FEDERAL FACILITY AGREEMENT AND CONSENT ORDER (FFACO)

RECORD OF TECHNICAL CHANGE (ROTC)

Corrective Action Unit (CAU) Number: 550

CAU Description: Smoky Contamination Area

Figure A.5-6
Study Group 3 Removable Radioactive Contamination Swipe Survey Locations

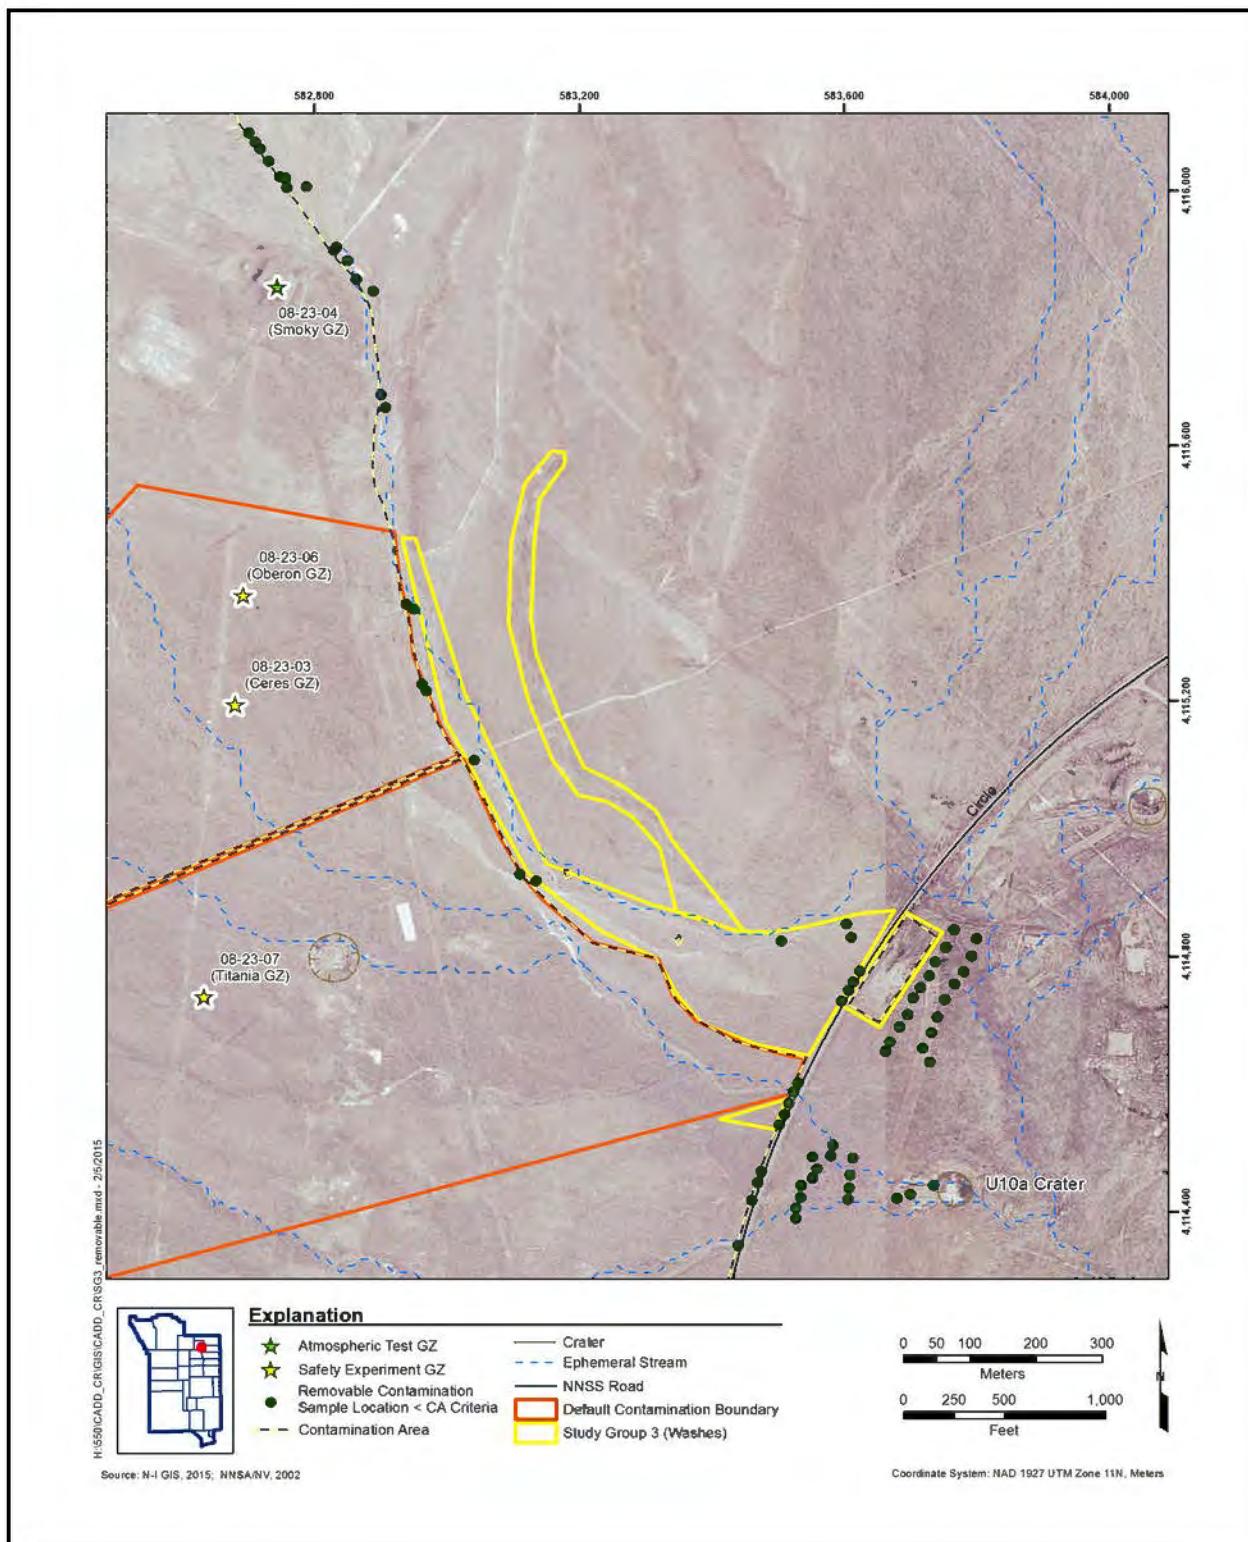
17.) Section A.5.6, Page A-63, Figure A.5-6		Suggest color code removable contamination sample locations to show samples meeting CA posting criteria IAW Figure A.4-3.	The symbol label for the green dots in the Figure A.5-6 legend has been changed to "Removable Contamination Sample Location < CA Criteria" to be consistent with the legend in Figure A.4-3.
